PLANNING COMMISSION REPORT
APRIL 14, 2026 AGENDA

Agenda Item:	Subject:	Submitted By:
Agenda Items 6B and 7B	Application for Revised Preliminary Plat and Final Plat submitted by Belcaro Development LLC (“Subdivider”) and Gregory Mahloch (“Owner”) for property generally located at the Southwest Corner of 132 nd Street & Platteview Road, Springfield, NE	Kathleen Gottsch City Administrator

SYNOPSIS OF PROFESSIONAL STAFF COMMENTS FOR PLANNING COMMISSION & CITY COUNCIL

Lots 1-133 and Outlots A-L Gregory Mahloch (Owner)/Joseph Gomez, Belcaro Development (Subdivider)/TD2 (Agent) Revised Preliminary Plat & Final Plat

Sheet Title
**SPRINGFIELD, NEBRASKA
SARPY COUNTY
FINAL PLAT**
Sheet Number

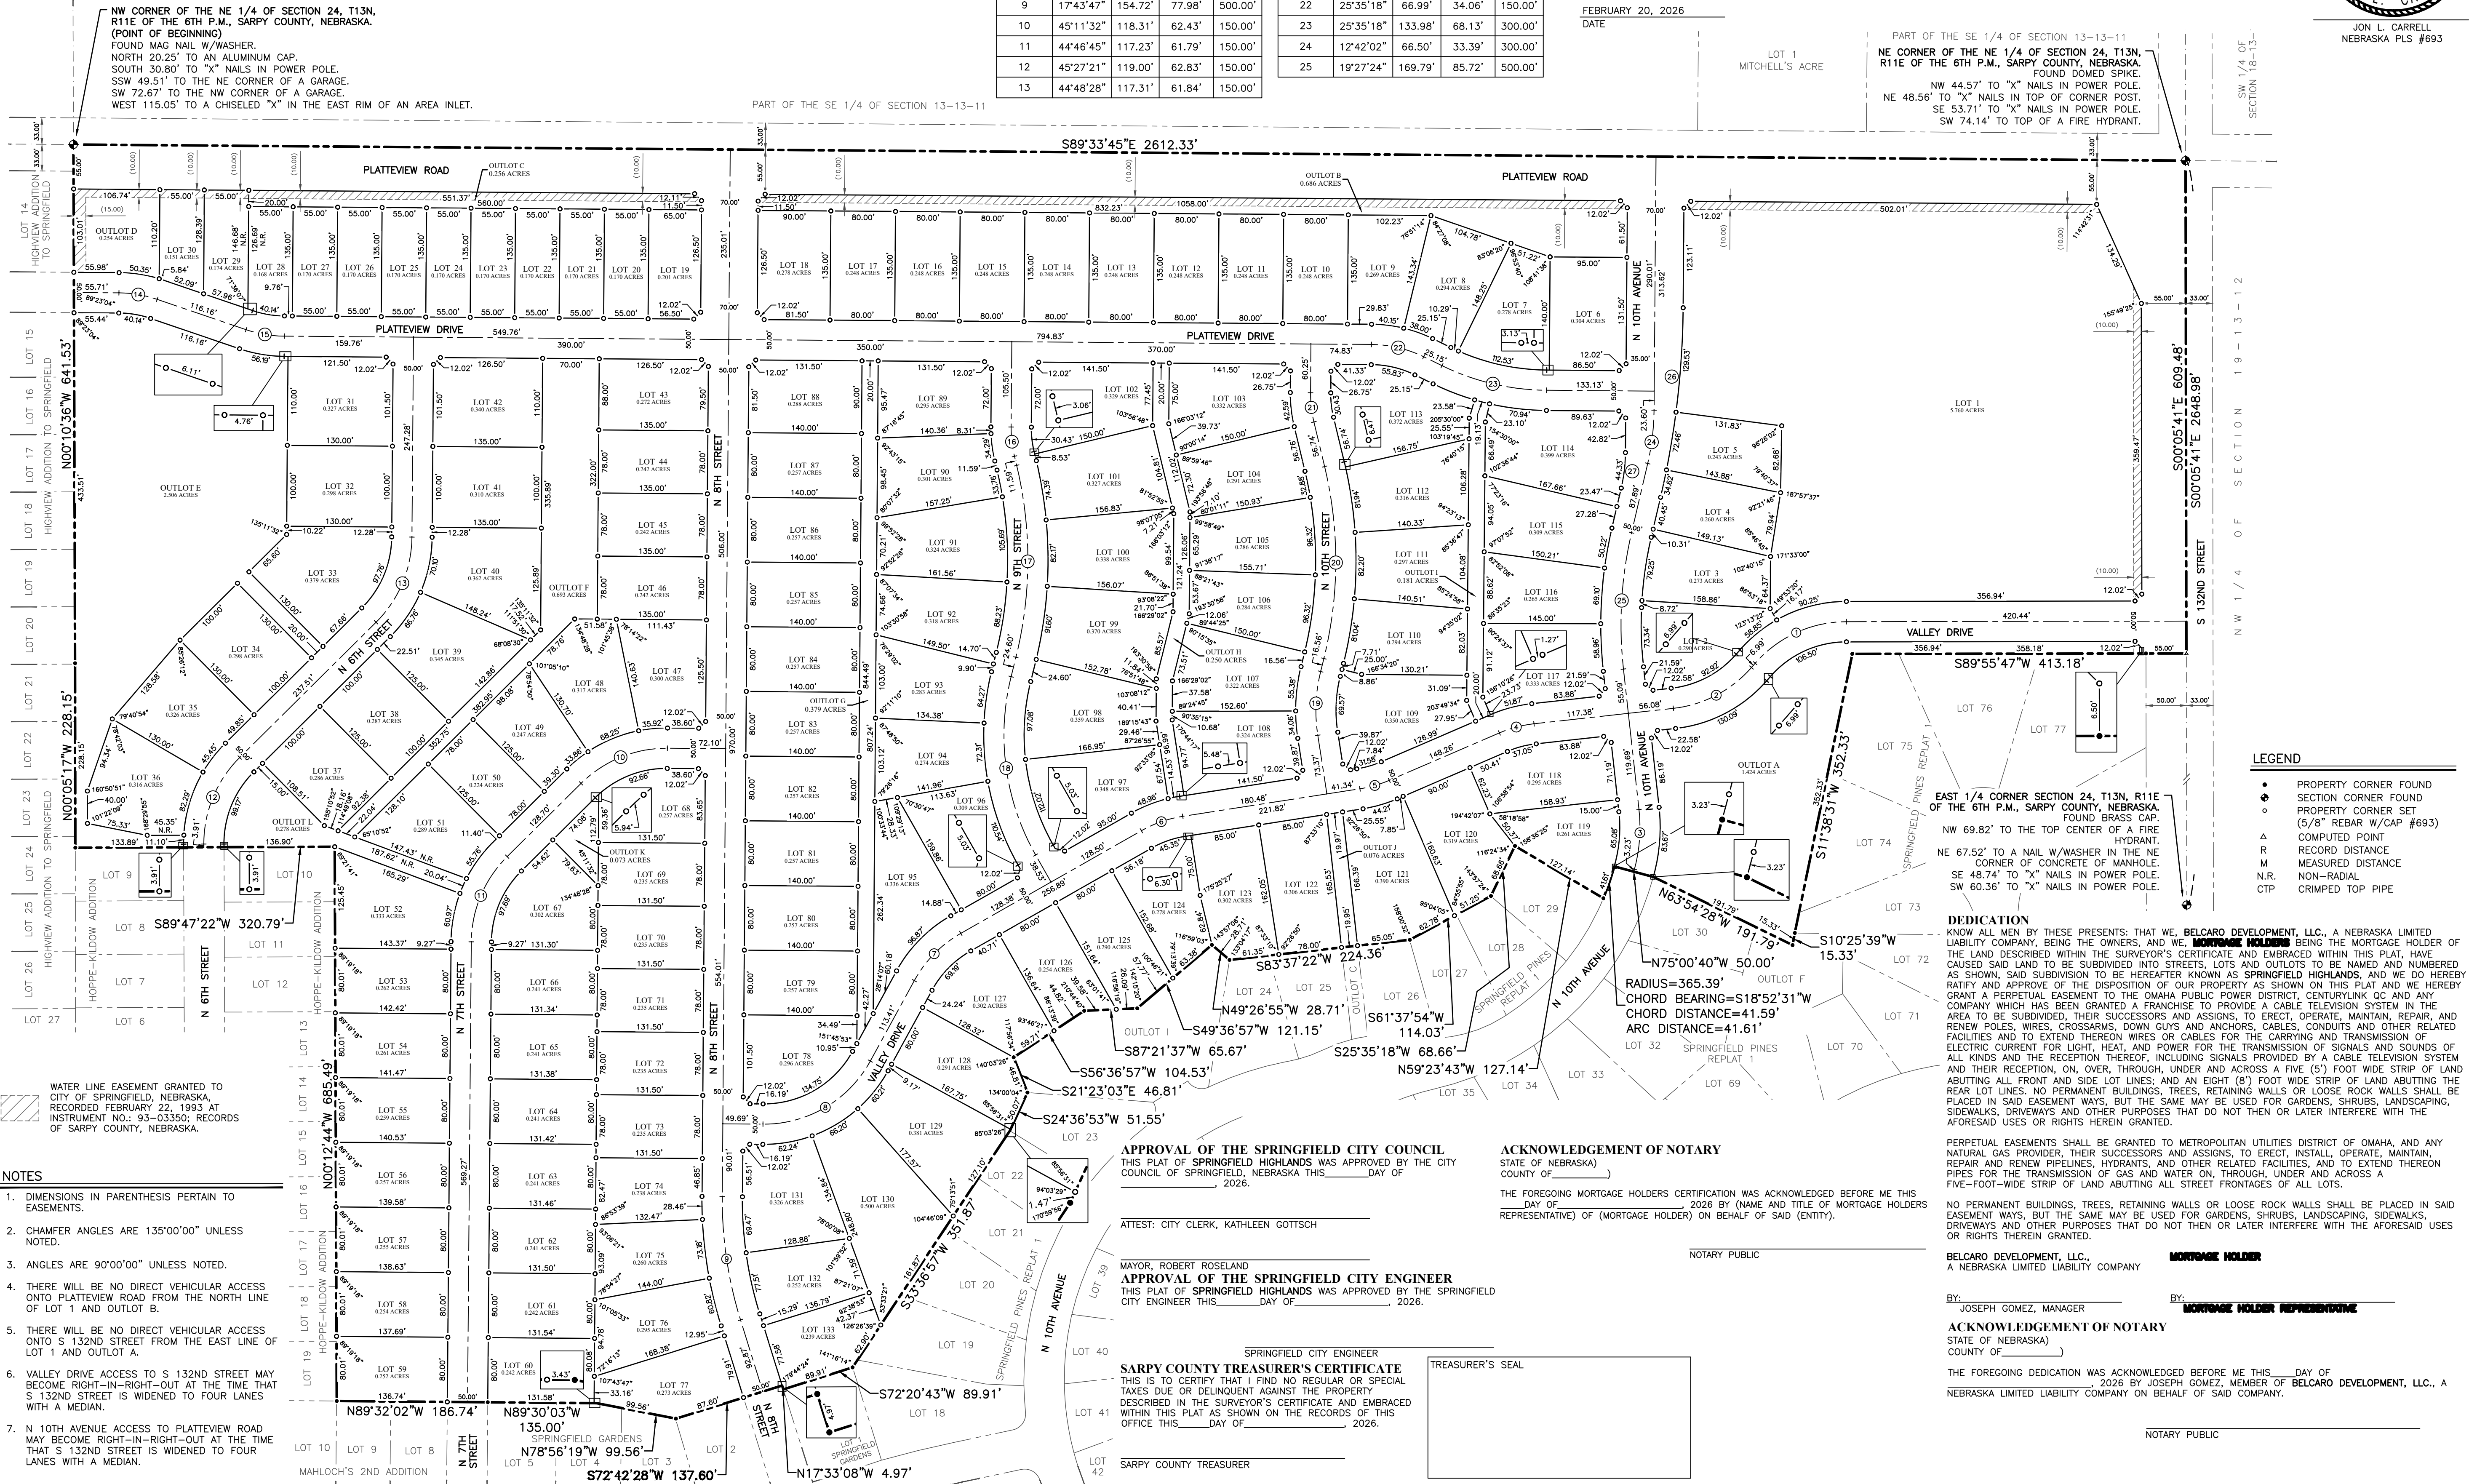
1. Add "Dedication" on Main Street and 132nd Street.
2. Add Range Number to the section by the Land Surveyor's stamp on drawing.
 - a. Currently, the plat shows "SW ¼ of Section 18-13-"
3. Add "Drives" in the dedication block.
 - a. "...BEING THE MORTGAGE HOLDER OF THE LAND DESCRIBED WITHIN THE SURVEYOR'S CERTIFICATE AND EMBRACED WITHIN THIS PLAT, HAVE CAUSED SAID LAND TO BE SUBDIVIDED INTO STREETS, DRIVES, LOTS AND OUTLOTS..."
